E/ECE/324
E/ECE/TRANS/505 } Rev.1/Add.40/Rev.1/Amend.1

Addendum 40: Regulation No. 41

Revision 1 - Amendment 1

UNIFORM PROVISIONS CONCERNING THE APPROVAL OF MOTORCYCLES WITH REGARD TO NOISE

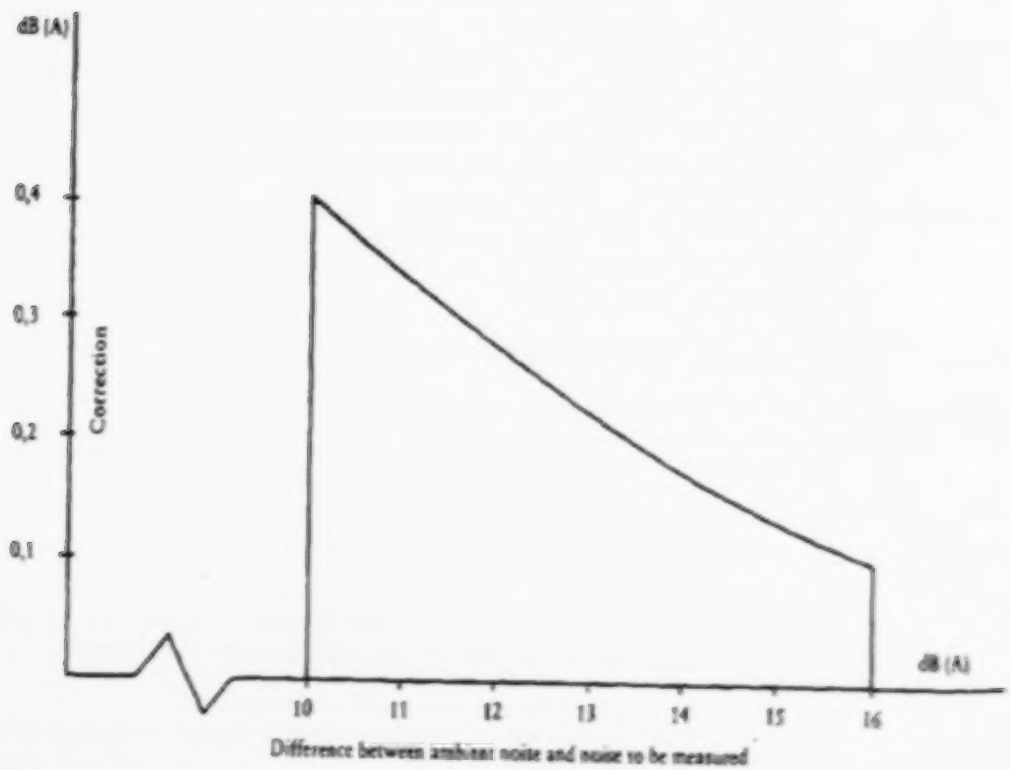
If the difference between the ambient noise and the measured noise is between 10 and 16 dB(A), in order to calculate the test results the appropriate correction shall be subtracted from the readings on the sound-level meter, as in the following graph:

Figure 1

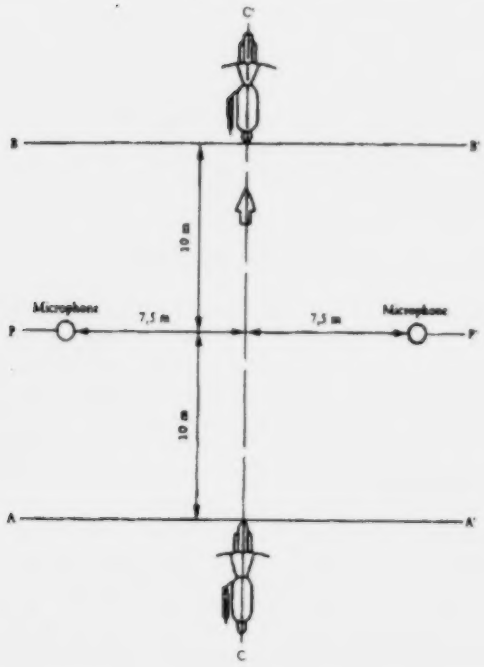
The maximum sound level expressed in A-weighted decibels (dB(A)) shall be measured as the motorcycle travels between lines AA' and BB' (figure 1). The measurement will be invalid if an abnormal discrepancy between the peak value and the general sound level is recorded.
At least two measurements shall be taken on each side of the motorcycle.

The microphone shall be located 7,5 m ± 0,2 m from the reference line CC (see appendix - Figure 1) of the track and 1.2 m ± 0,1 m above ground level.

Figure 2
Test for stationary vehicle

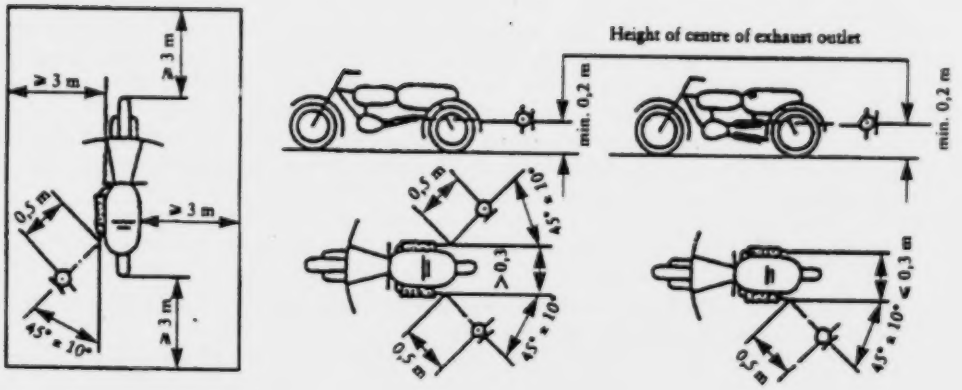
2.3.2. Test site (See appendix - figure 2)

2.4.2. Positioning of the microphone (See appendix - figure 2)

The microphone shall be positioned level with the exhaust outlet or 0.2 m above the surface of the track, whichever is the highest. The microphone diaphragm shall face towards the

exhaust outlet at a distance of 0.5 m from it. The axis of maximum sensitivity of the microphone shall be parallel to the surface of the track at an angle of 45° ± 10' to the vertical plane of the direction of the exhaust emissions.

Figure 1: Minimum requirements for test surface area. The shaded part is called "Test Area".

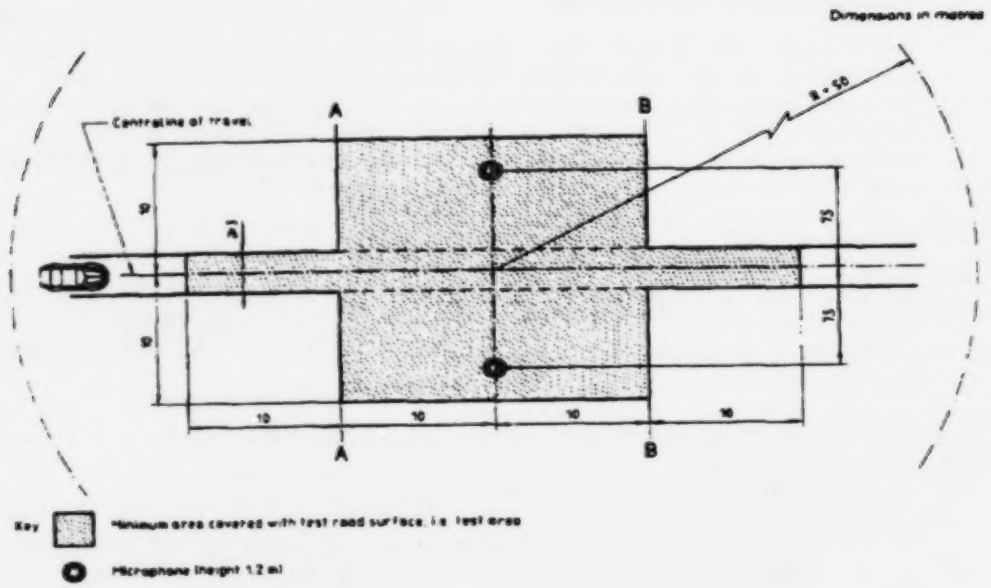
When designing the test track layout it is important to ensure that, as a minimum requirement, the area traversed by the vehicles running through the test strip is covered with the specified test material with suitable margins for safe and practical driving. This will require that the width of the track is at least 3 m and the length of the track extends beyond lines AA and BB by at least 10 m at either end. Figure 1 shows a plan of a suitable test site and indicates the minimum area which shall be machine laid and machine compacted with the specified test surface material. According to annex 3, paragraph 3.1.1.1., measurements have to be made on each side of the vehicle. This can be made either by measuring with two microphone locations (one on each side of the track) and driving in one direction, or measuring with a microphone only on one side of the track but driving the vehicle in two directions. If the former method is used, then there are no surface requirements on that side of the track where there is no microphone.

Figure 2: Grading curve of the aggregate in the asphaltic mix with tolerances

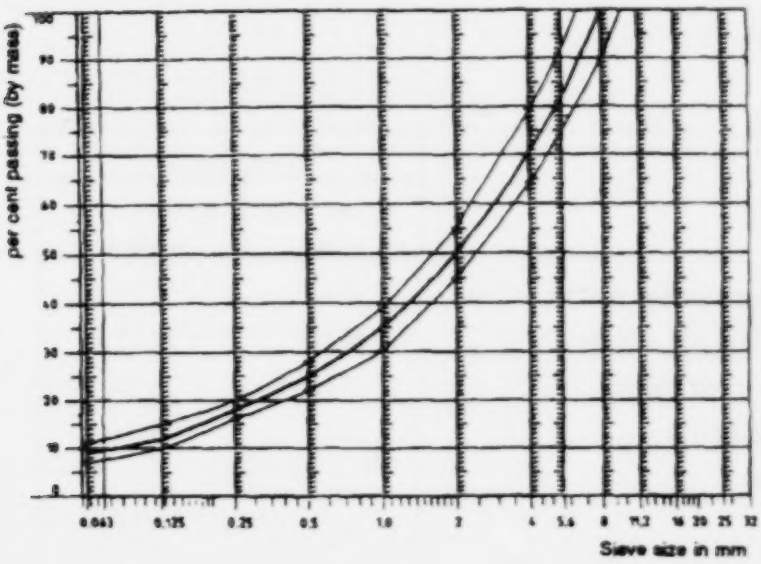
As a guide to the surface constructor, an aggregate grading curve which will give desired characteristics is shown in Figure 2. In addition, Table 1 gives some guidelines in order to obtain the desired texture and durability. The grading curve fits the following formula:

$$P\ (\%\ \text{passing}) = 100\ .\ (d/d_{max})^{1/2}$$

where: d = square mesh sieve size, in mm
d_{max} = 8 mm for the mean curve
d_{max} = 10 mm for the lower tolerance curve
d_{max} = 6.3 mm for the upper tolerance curve
